On The PoC Inductor Selection

IEEE 802.3dm Task Force

New 6.8uH PoC Inductor!

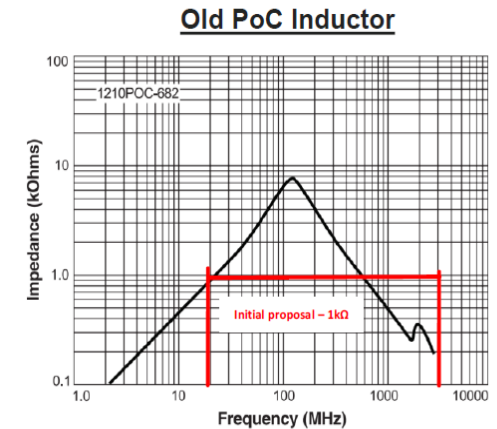
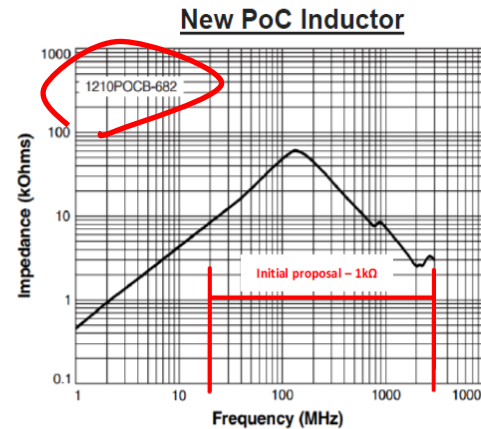
- The so called “New PoC inductor” plot¹ is easily calculated from low frequency impedance to be 68.2μH and **not** 6.8μH! (a typo?)
- The referenced link shows the plot for 1210POCB-682 which is a 6.82μH and not as shown in the presentation². With that, the stated proposal of staying above 1kOhm over whole bandwidth is not achieved.

Mystery PoC Inductor for FDD³

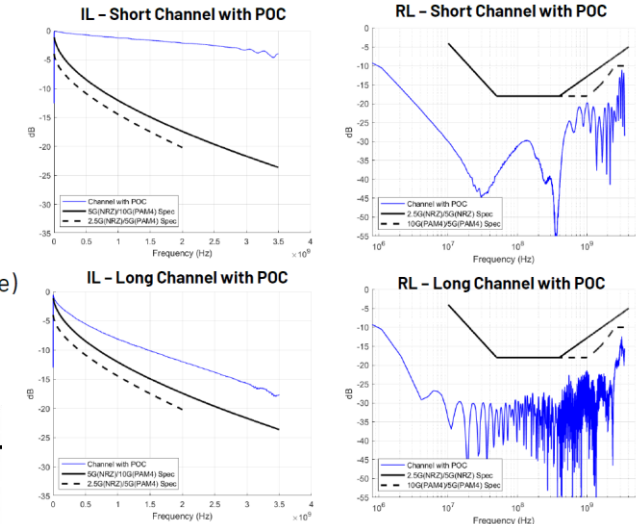
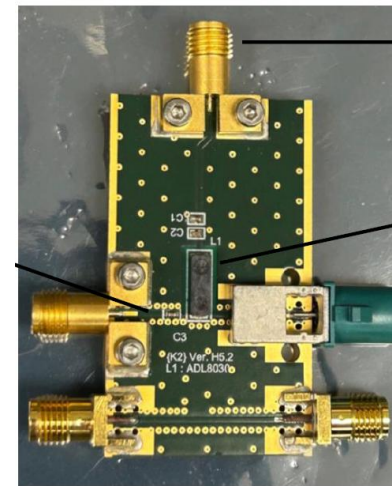
- The Return Loss plots for FDD³, clearly show the proposed PoC inductor has inductance of greater than 10 μ H.
- The part number was not disclosed!
- The self resonance frequency of the inductor when installed on the board is seen to be about 30MHz.
- DCR of the inductor and power rating is not disclosed.
- The size of the inductor is not provided but judging by the connector size on the board, It should be about 8mm by 2mm.
